Project No. 20056

Client  
Nathan Harley (Resource Buildings & Interiors Ltd)  
Date  
Jan 2022  
Scale  
1:50 @ A1 / 1:100 @ A3  
Project  
38 Chester Terrace  
NW1 4ND

Drawing Title  
Proposed Roof Plan

| Drawing No. P2005 |                | Rev. B       |

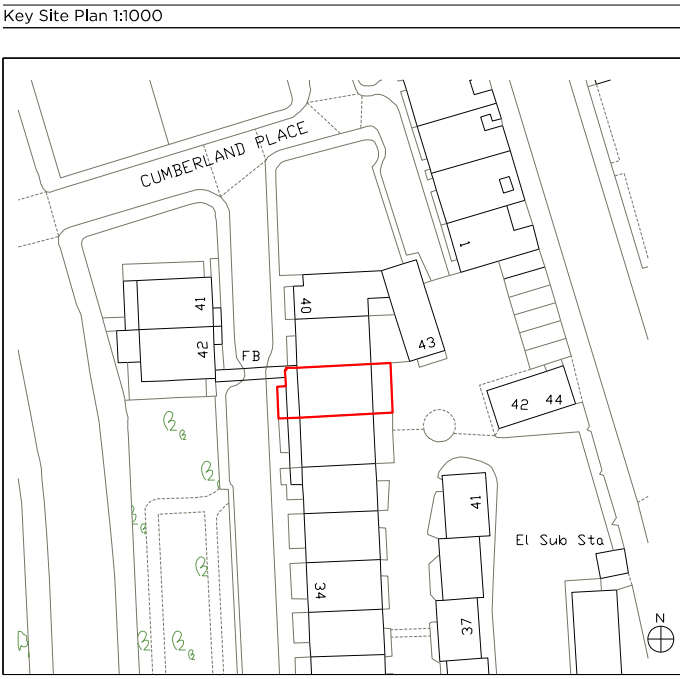
| Revision Notes |   |            |
|----------------|---|------------|
| B.1            | Condenser units removed from edge of roof |            |
| B.1            | New Rooflight                             | 03.03.2022 |
| B.3            | Roof terrace removed.                     |            |
| B.4            | Condenser units removed from roof         |            |
